An Even More Fool-Resistant Conditional Sequencer

Errata November 2012

Errata October 2009

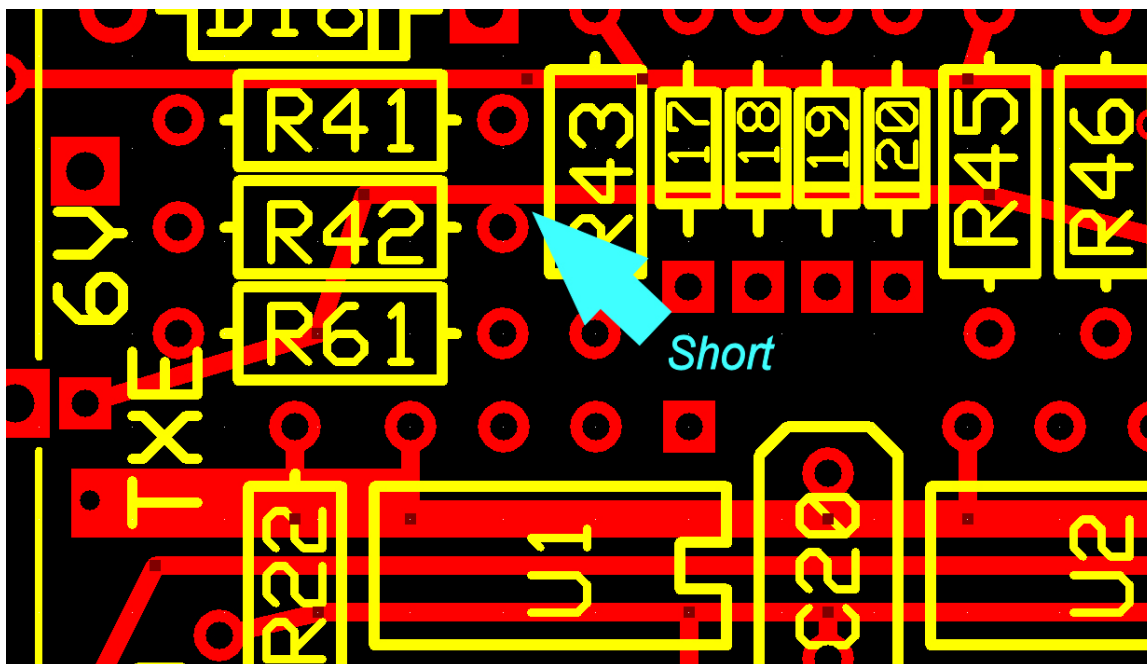
I thought all the errors in the 2009 boards were fixed in the batch of boards marked **W1GHZ 2011a**, but one new error crept in. As shown in the sketch below, one R42 pad is shorted to the adjacent trace on the top side of the board. Since R42 only connects to a trace on the back side (not shown), this is easily fixed with an X-Acto knife by cutting away part of the topside pad to remove the short.
